7 October 2014

Brian Gibson
Senior Development Planner
Lake Macquarie Council
126-138 Main Road
SPEERS POINT NSW 2284

DA251/2013 Masters Windale: Response to Request for Information

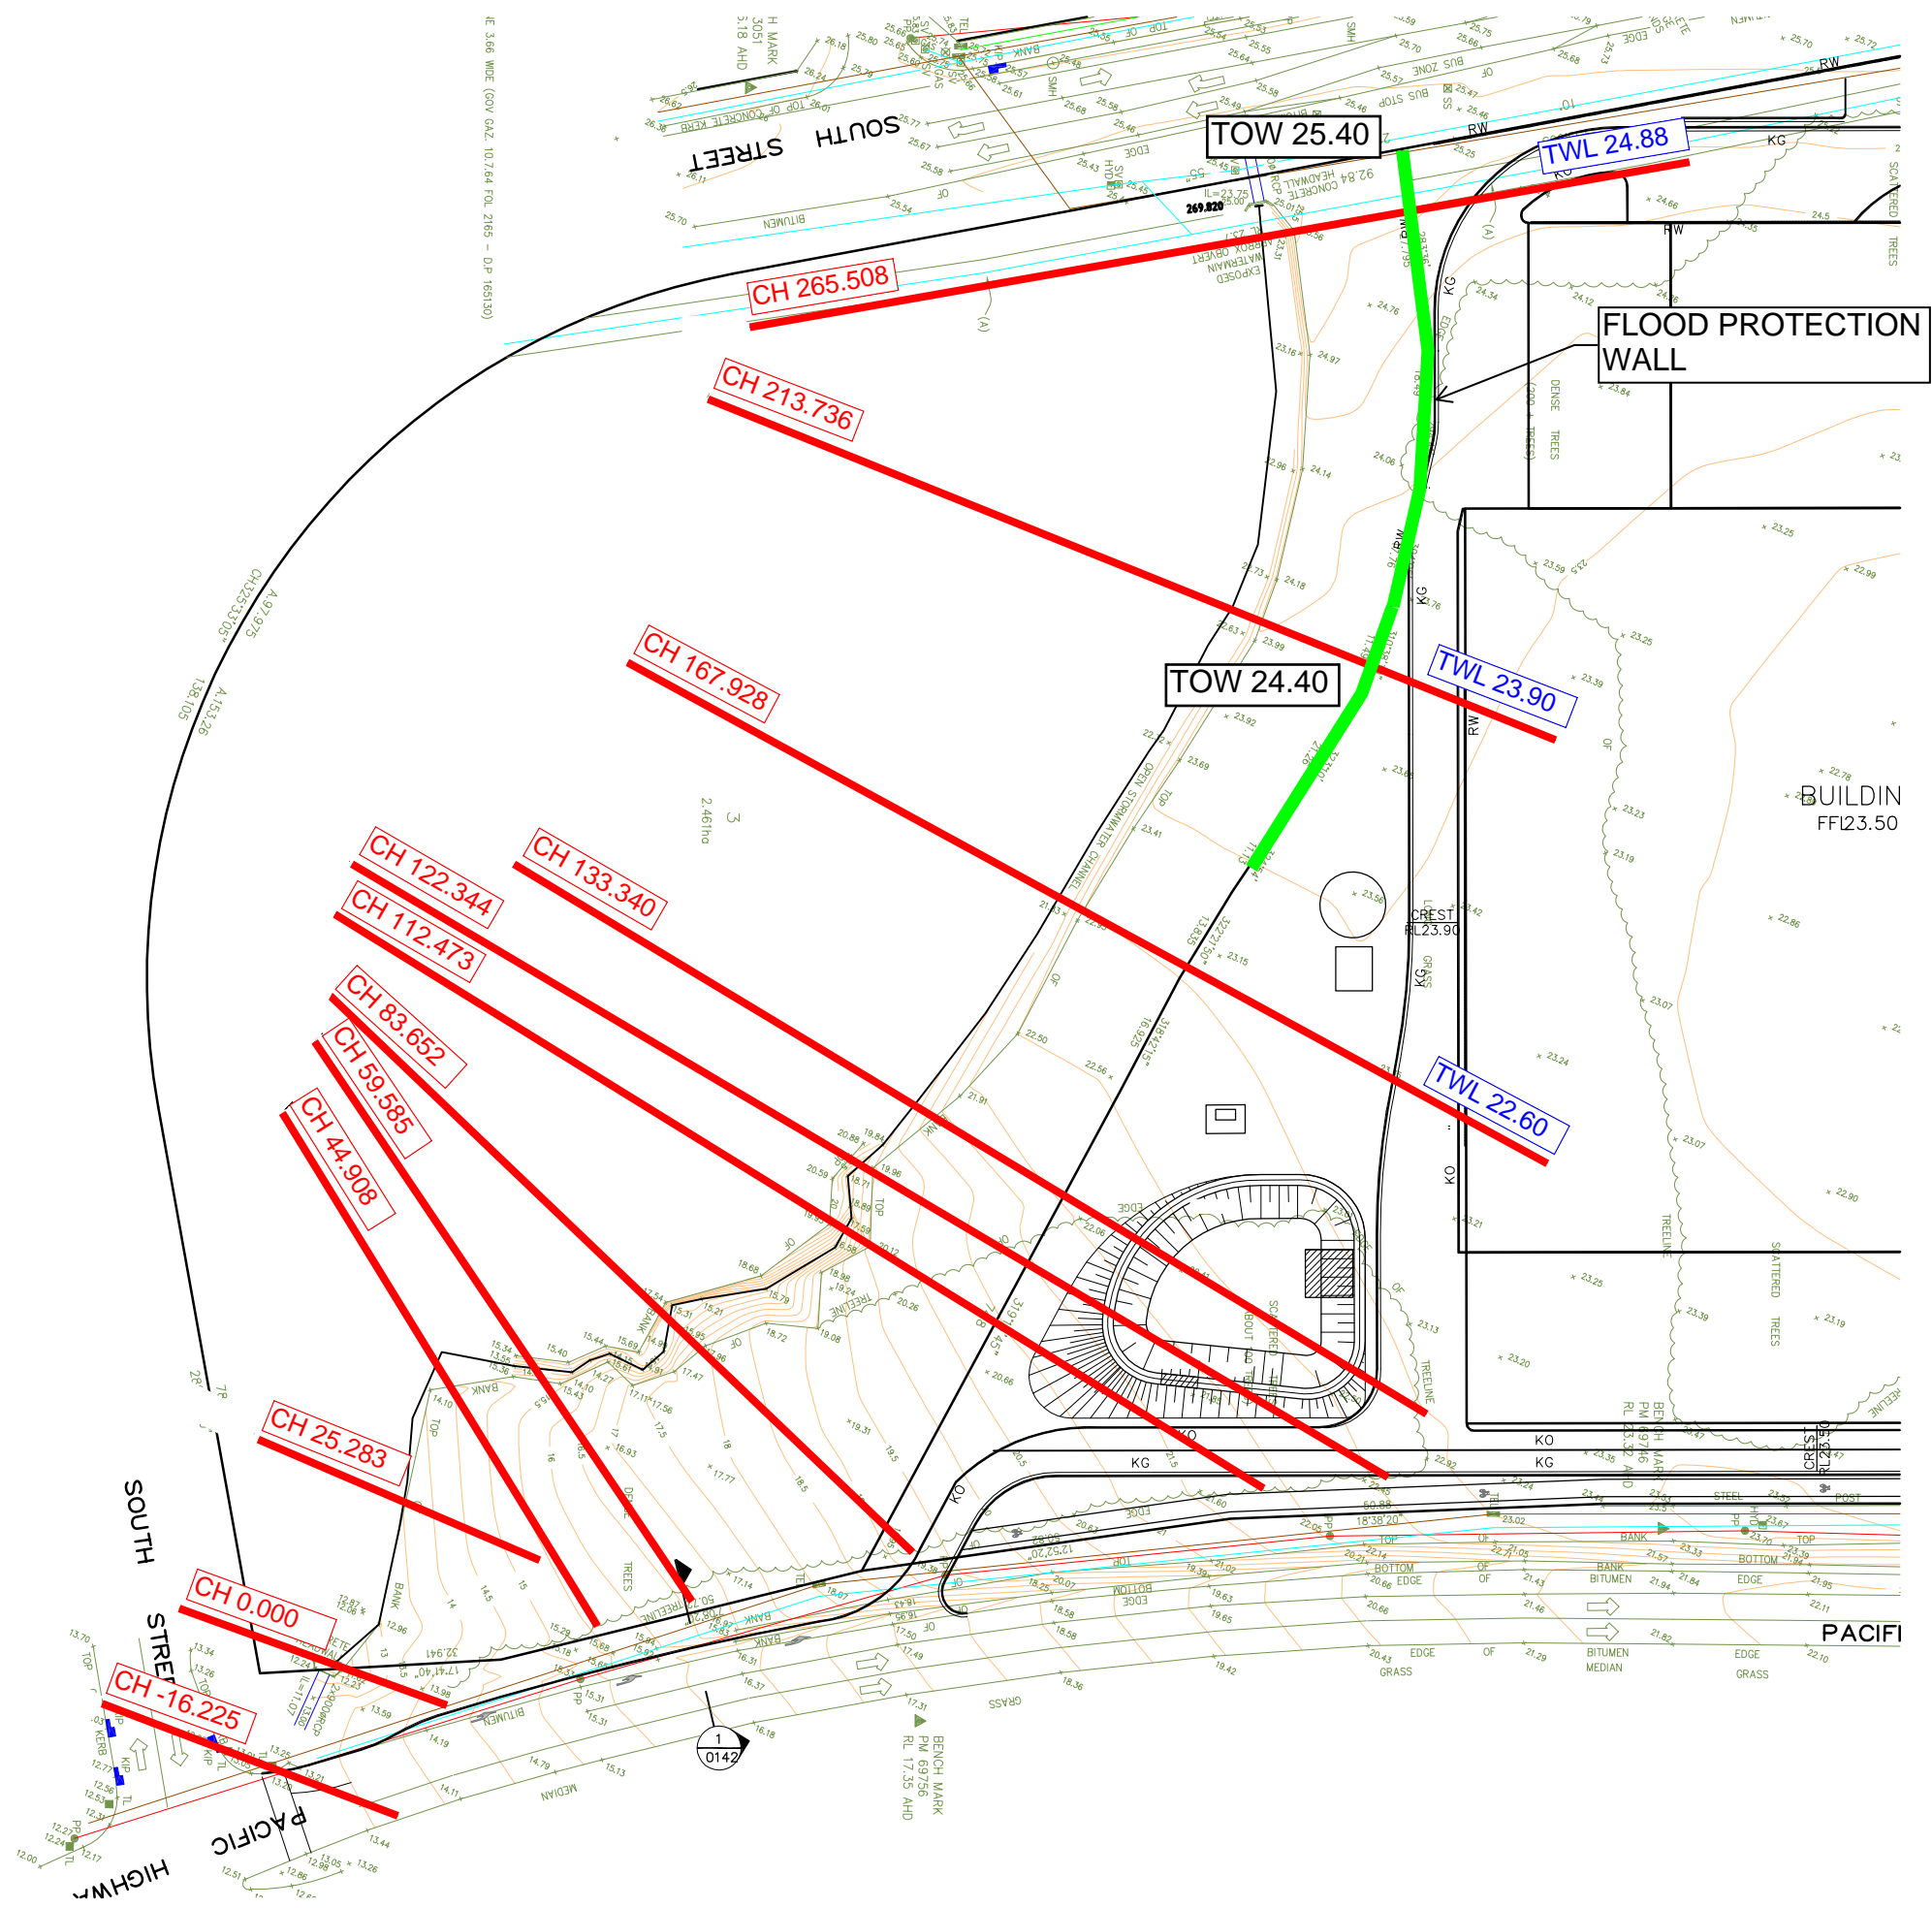
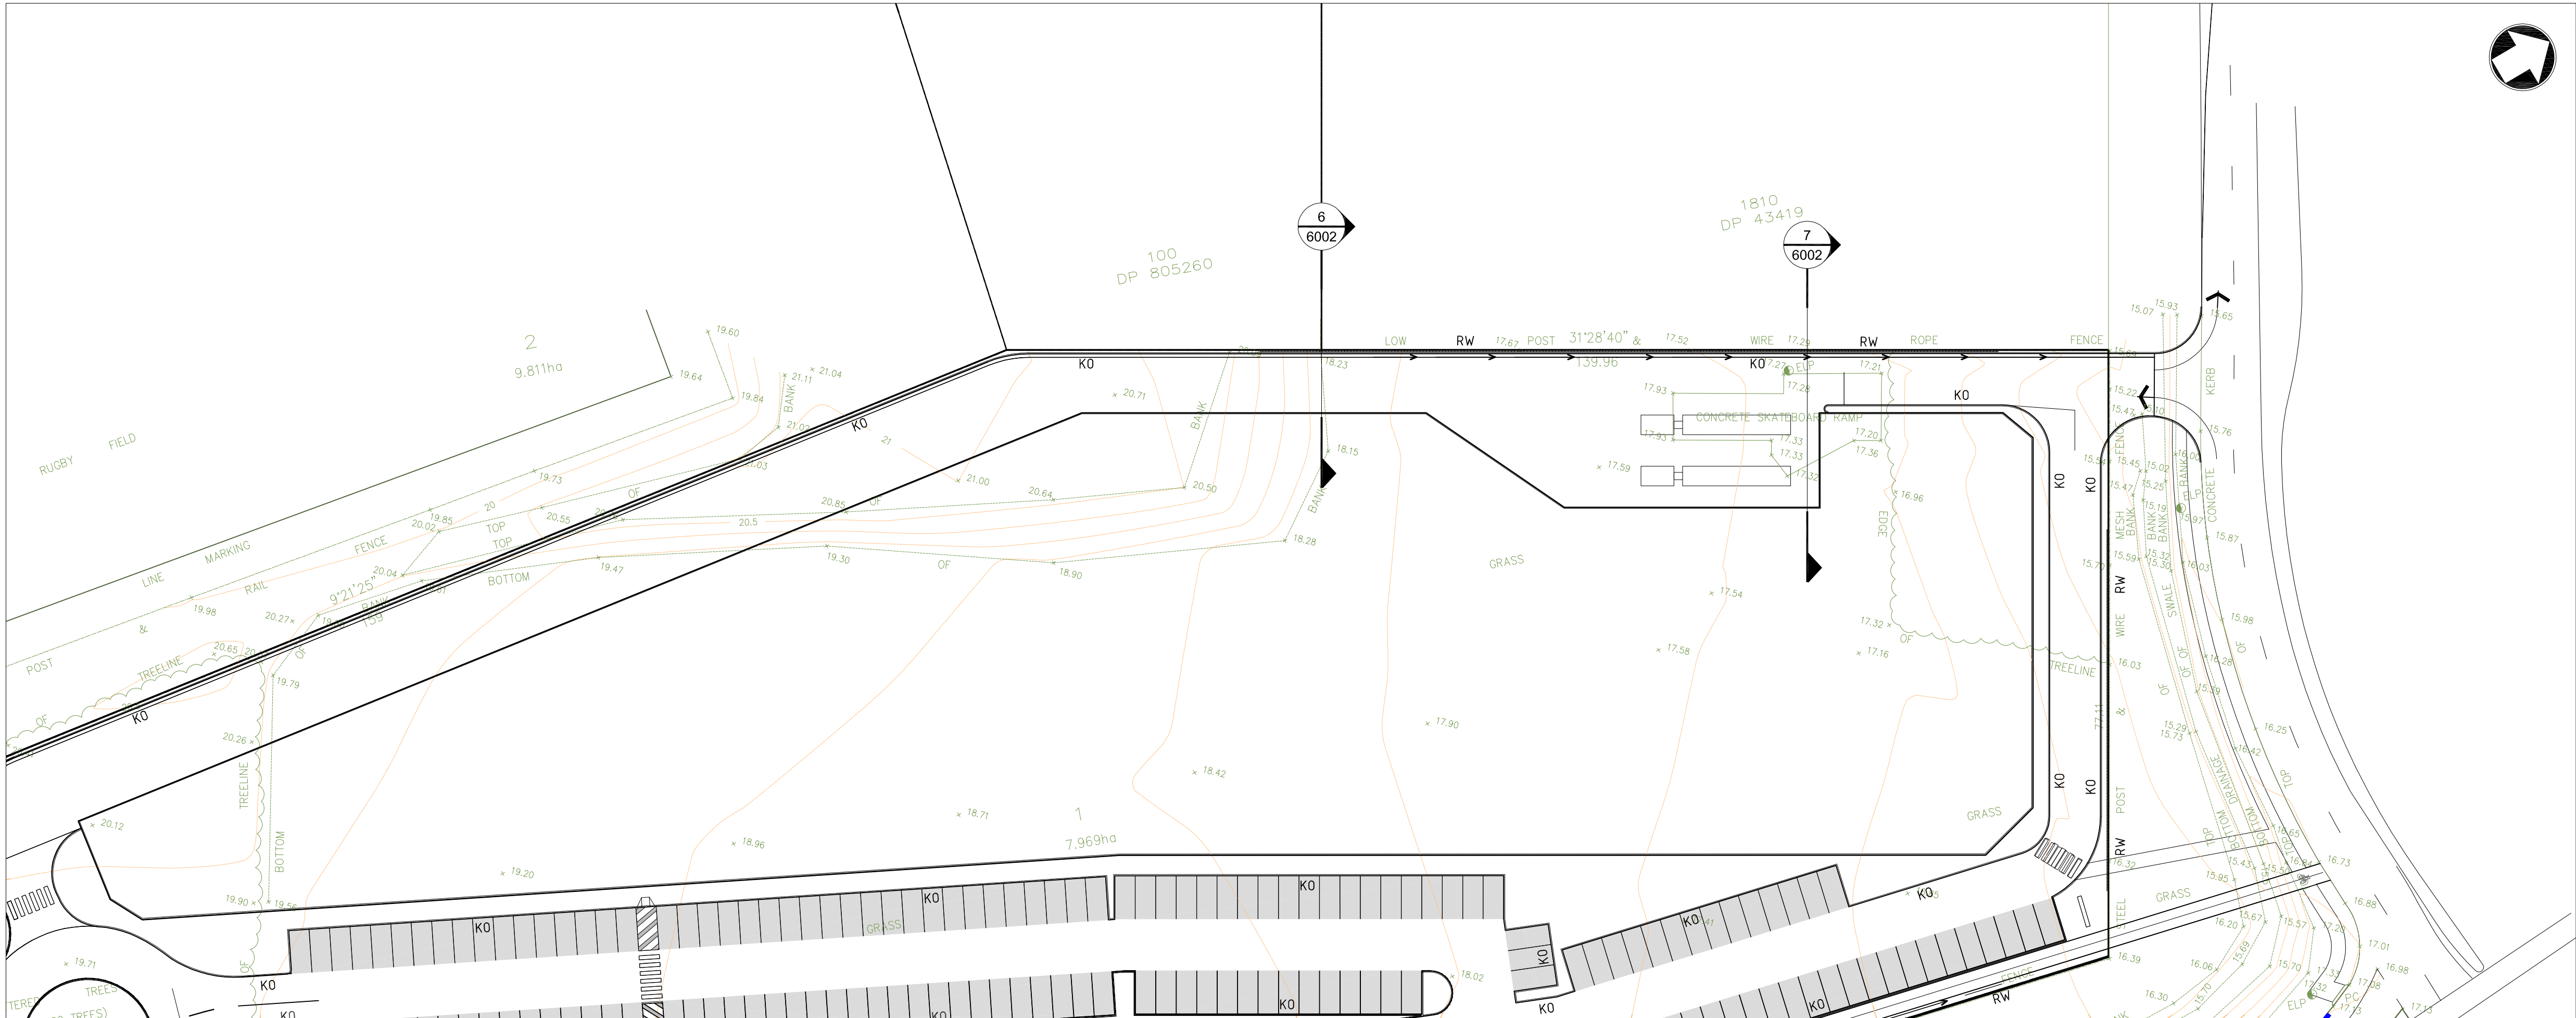
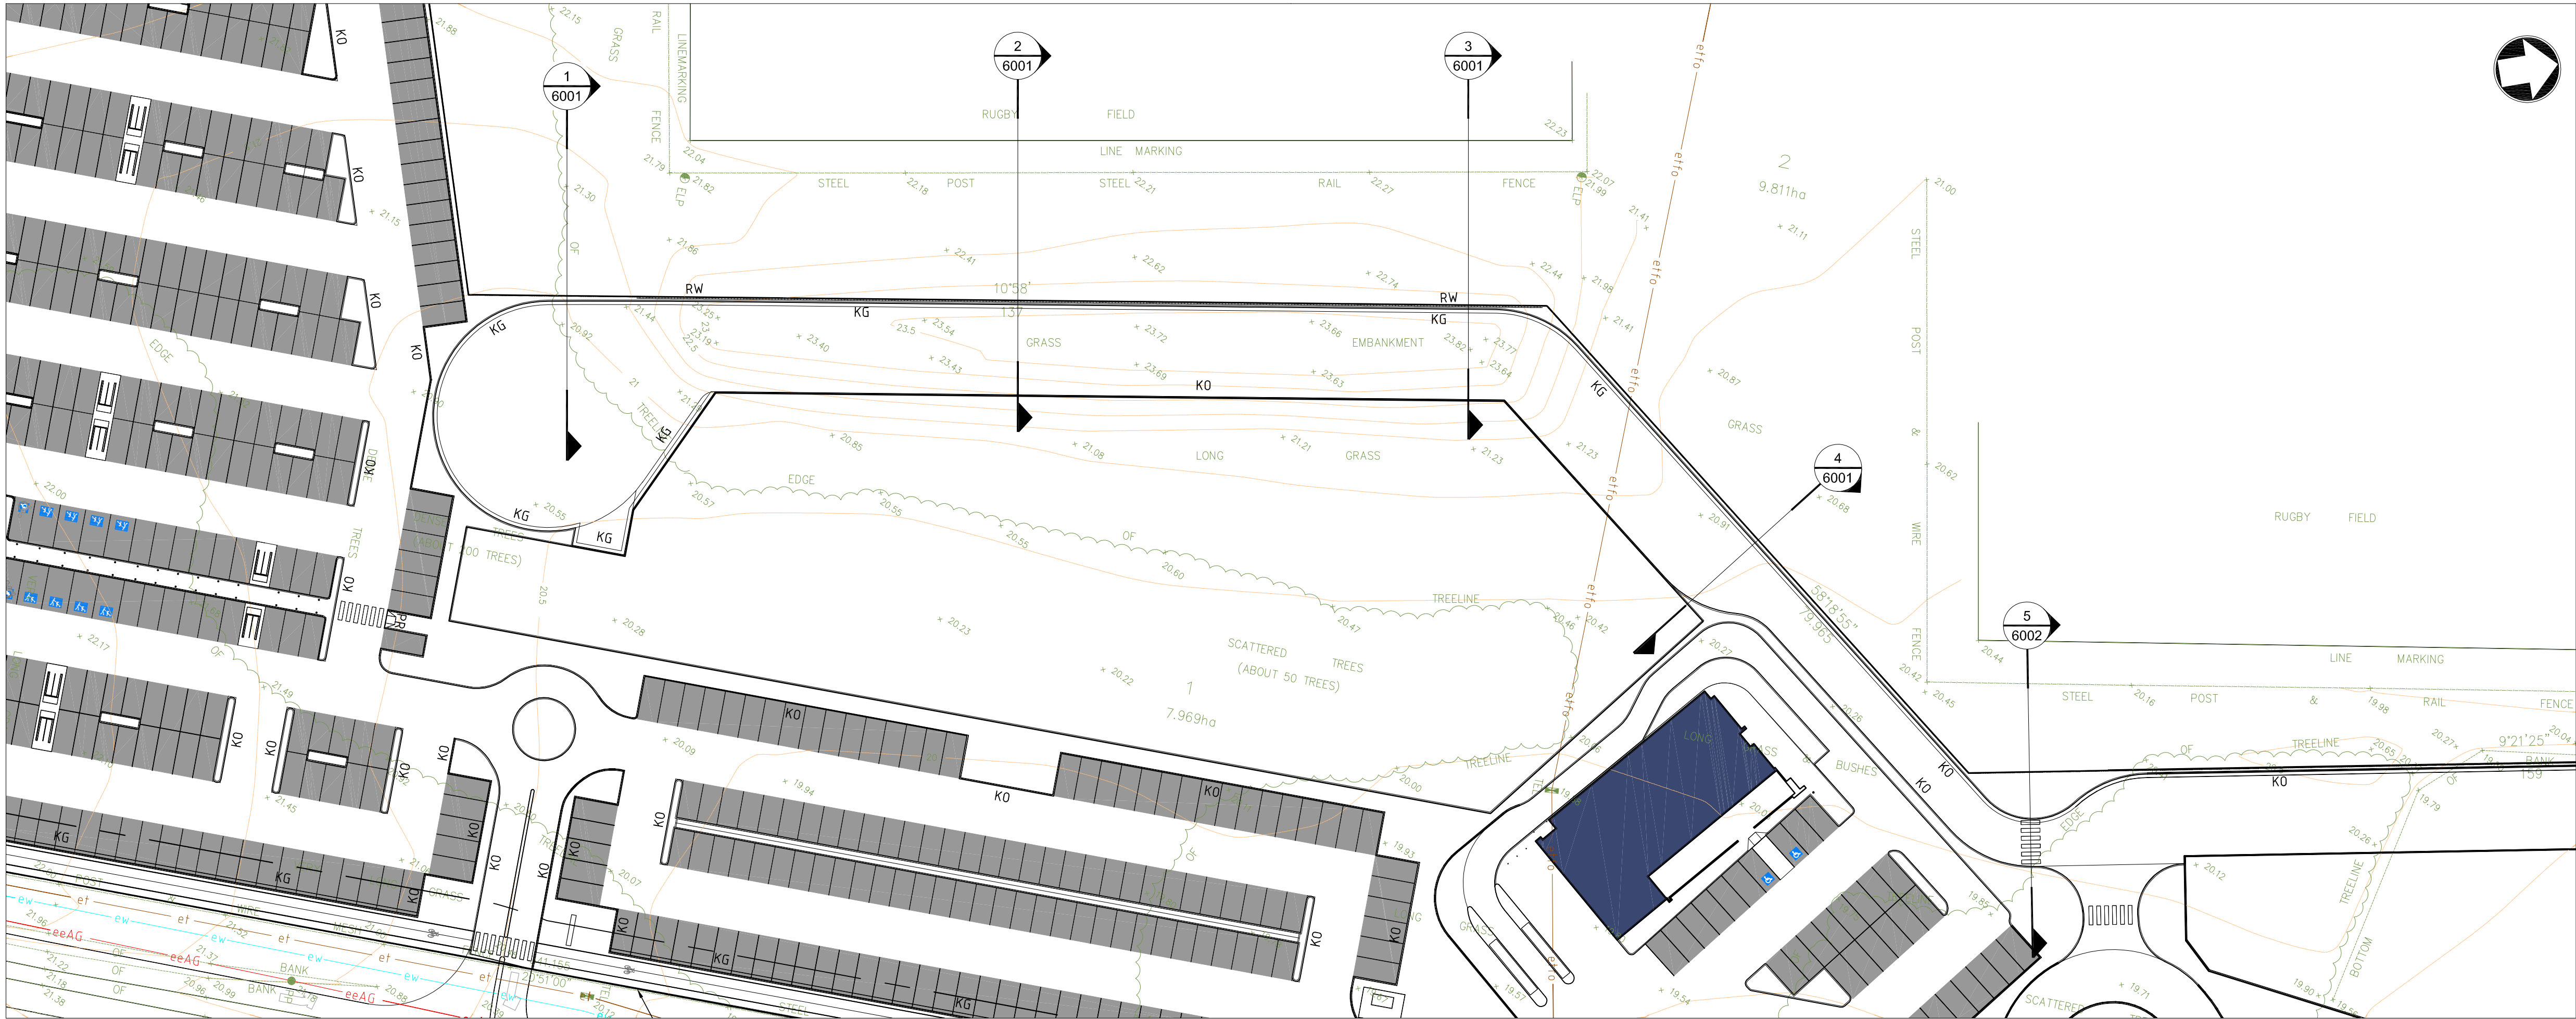
Currently, the finished floor level of the proposed commercial development is nominated as FFL 23.50m AHD. While we acknowledge that this level is below the minimum flood planning level of FFL 25.38m AHD as specified by Council ($24.88 + 0.5\text{m freeboard} = 25.38$), we propose the following remediation measures to manage the on-site flood risk of the building for Council's review and in-principal approval:

- maintain the finished floor level of the building at FFL 23.50m AHD as currently documented to improve the vehicular and pedestrian connectivity to the site from the Pacific Highway to the east; and
- introduce a flood protection wall with a minimum height of RL25.40m AHD at the south-western boundary of the development area (refer attached for details), alternatively provide a flood protection bund situated in the neighbouring property, subject to Council approval.

Based on the above, we respectfully request that Council provide in-principal approval of the nominated building floor level of FFL23.50m AHD and site flood protection wall or bund.
